| PROJECT TITLE: Eastern and Millidgeville Wastewater Treatment Facilities and Lancaster Lagoon – Lighting Retrofit | ADD. NO: 1 |
| TENDER NO: 2022-082302T | DATE: September 1, 2022 |

Project Name: MBDER PKG #A10 - Eastern and Millidgeville Waste Water Treatment Facility and Landcaster Lagoon - Lighting Retrofit

ADD #: 1

Drawing No.
SKE-1

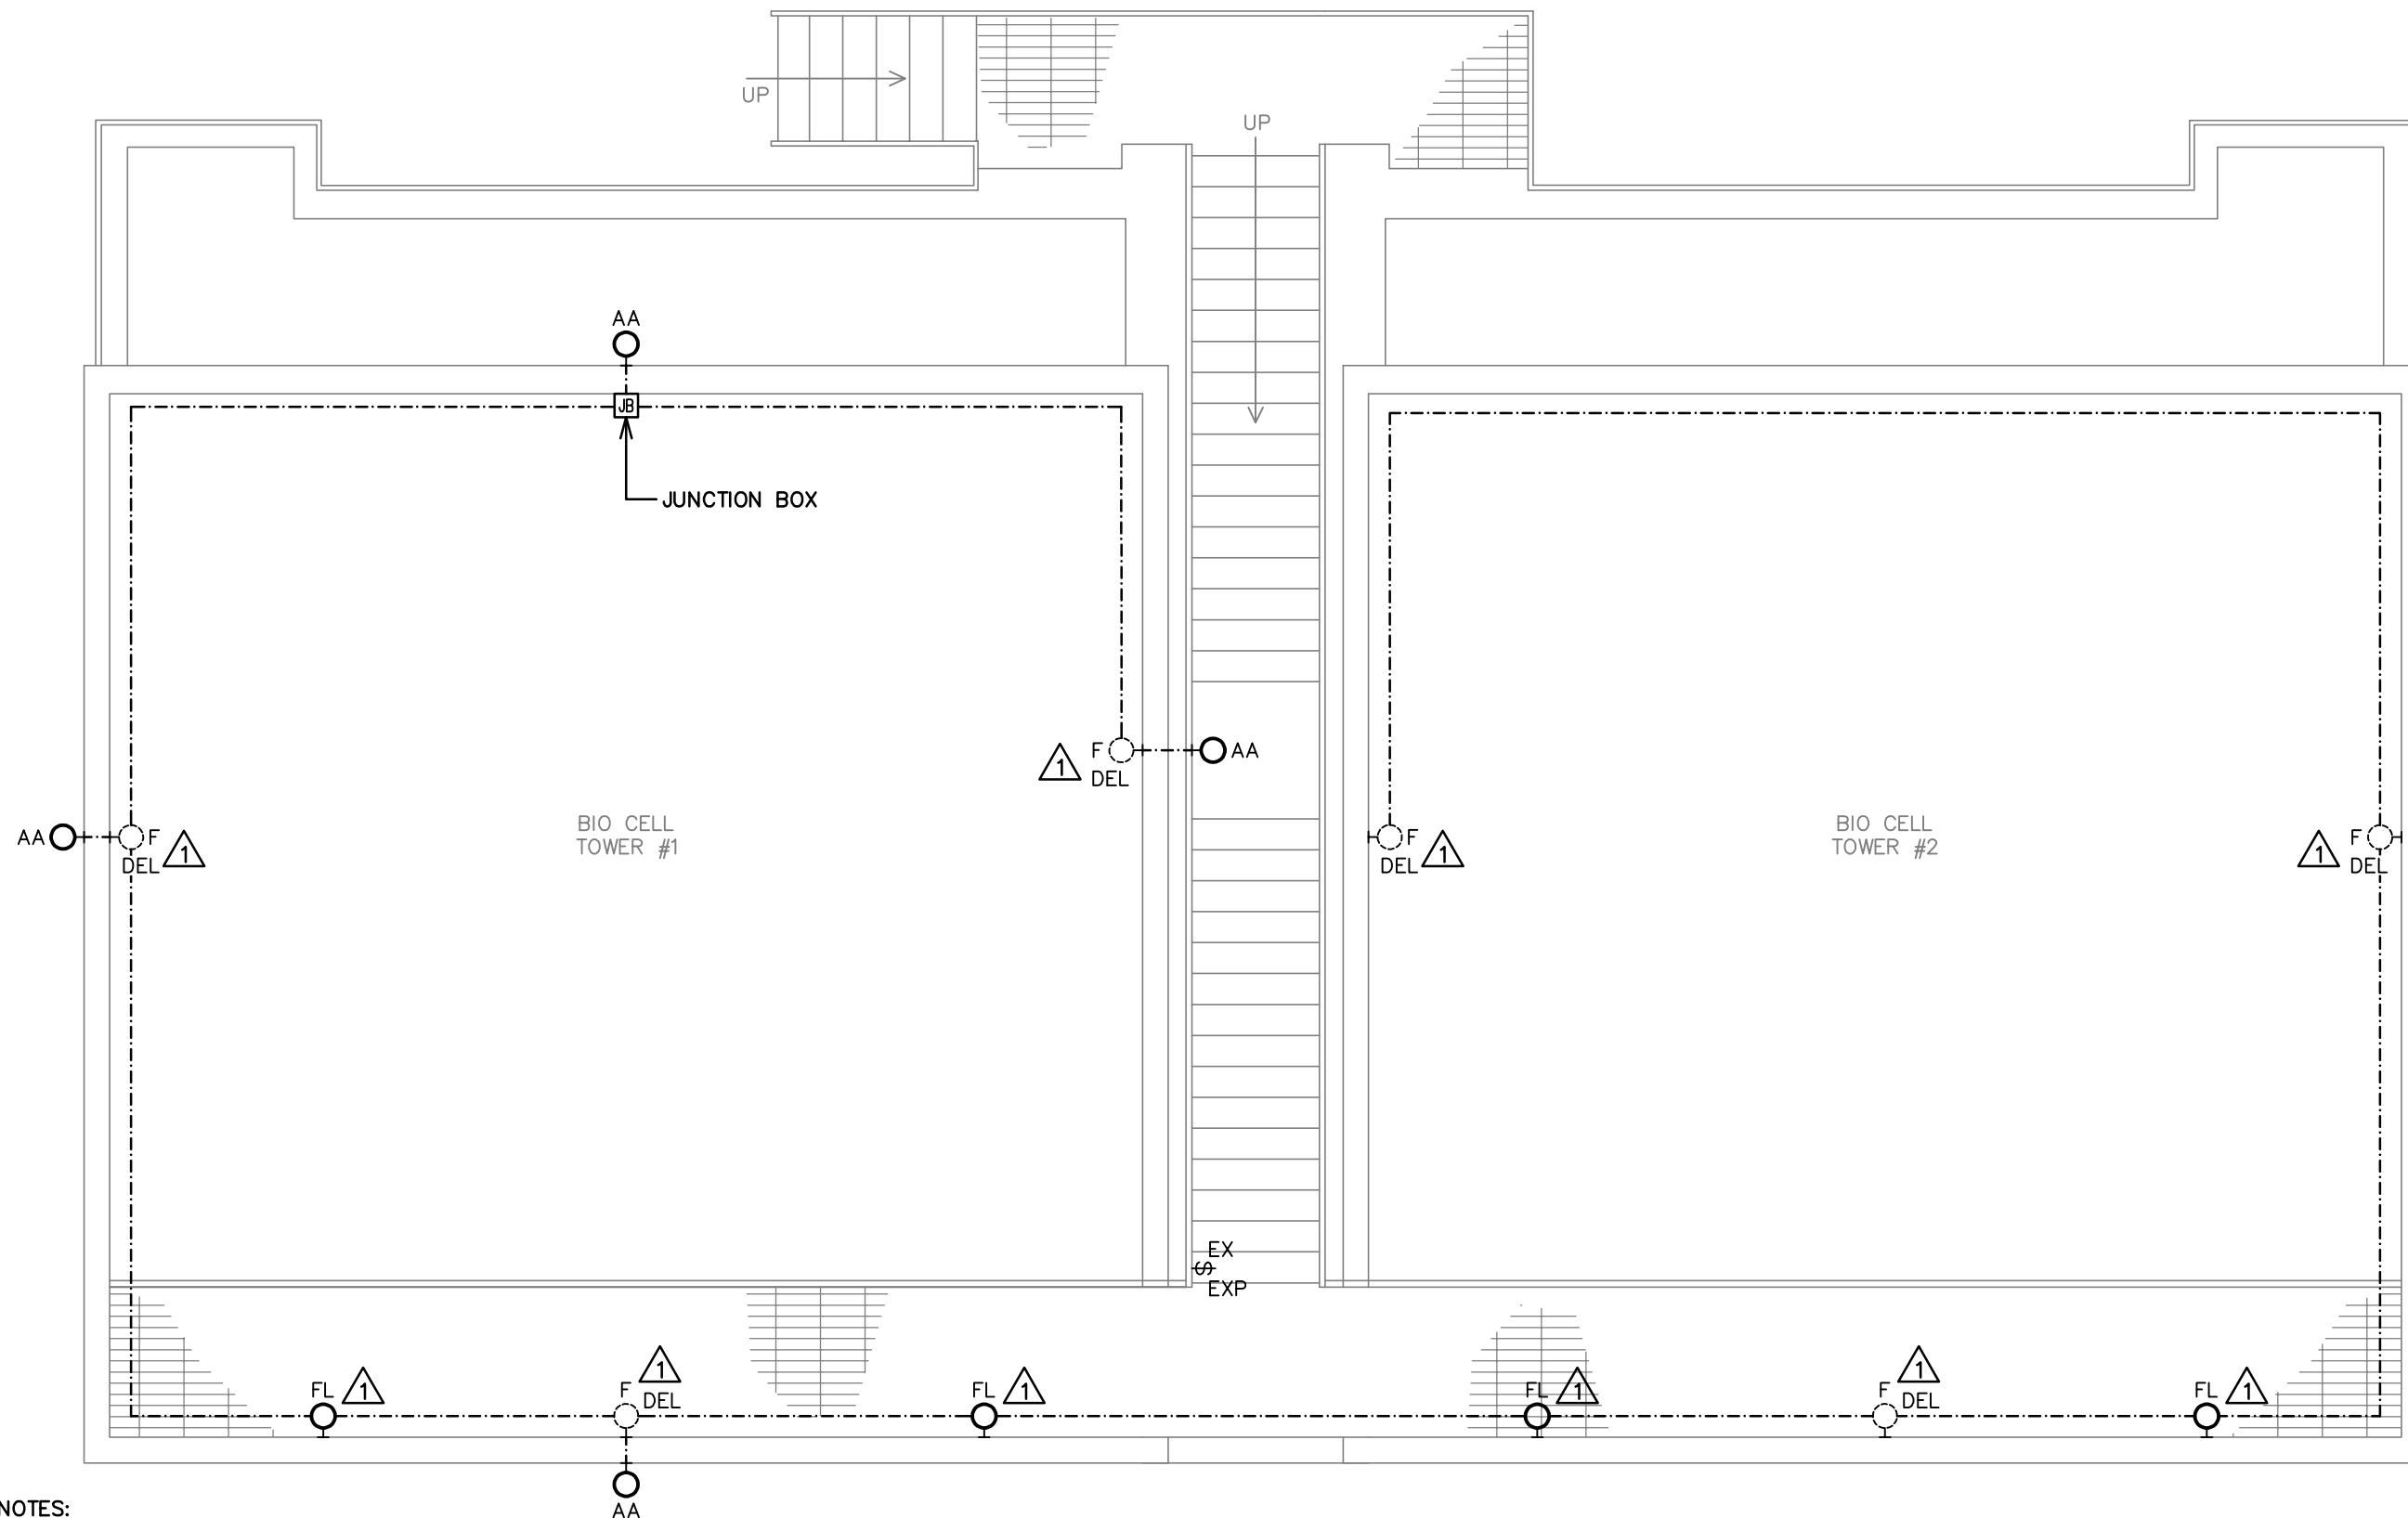
| Drawing # | Revisions |
|-----------|-----------------------------------------------------------------------------------------------------------------------------------------------------------------------------------------------------------------------------------------------------------------------------------------------------------------------------------------------------------------------------------------------------------------------------------------------------------------------------------------------------------------------------------------------------------------------------------------------------------------------------------------------------------------------------------------------------------------------------------------------|
| E-7 | <ul style="list-style-type: none">• Reference Detail 3: Bio-Cell Towers - Lighting:<ul style="list-style-type: none">• Remove all six (6) type "F" luminaires shown and install four (4) new type "FL" flood luminaires as directed on Sketch SKE-1. (See attached photos: Fig. 1, 2 & 3)• Reference Detail 4: Screen and Grit Building Floor Plan - Lighting:<ul style="list-style-type: none">• Reference Room 101:<ul style="list-style-type: none">• Both luminaires shall be measure "1421" in lieu of measure "AA" as noted. Contractor shall make correction on their "As-Built" drawing.• Suffice "EXP" next to light switch denotes "Explosion Proof". |

1. REMOVE ALL SIX (6) TYPE 'F' LUMINAIRES SHOWN, ALONG WITH ALL REDUNDANT CONDUIT AND WIRING. SEAL THE KNOCKOUT WITH APPROPRIATE PLUG.
2. SUPPLY AND INSTALL FOUR (4) TYPE 'FL' LUMINAIRES AS DESCRIBED IN ADDENDUM #1.
3. SUPPLY AND INSTALL FOUR (4) 2"Ø x 8' LONG RIGID GALVANIZED STEEL POLE FOR NEW TYPE 'FL' LUMINAIRES.
4. SUPPLY AND INSTALL 4" LONG GALVANIZED STEEL STRUT TO PARAPET WALL FOR FASTENING OF STEEL POLE.
5. FEED NEW LUMINAIRES WITH TECK90 CABLE C/W HAZARDOUS TYPE FITTINGS FROM NEW WEATHER TIGHT JUNCTION BOX STRAPPED TO POLE WITH GALVANIZED STRAPS.
6. EXTEND EXISTING CIRCUITRY IN NEW PVC CONDUIT AS REQUIRED. REUSE EXISTING CONDUIT WHERE POSSIBLE.
7. ATTACHED PHOTOS IN ADDENDUM #1 ARE FOR INFORMATION ONLY.
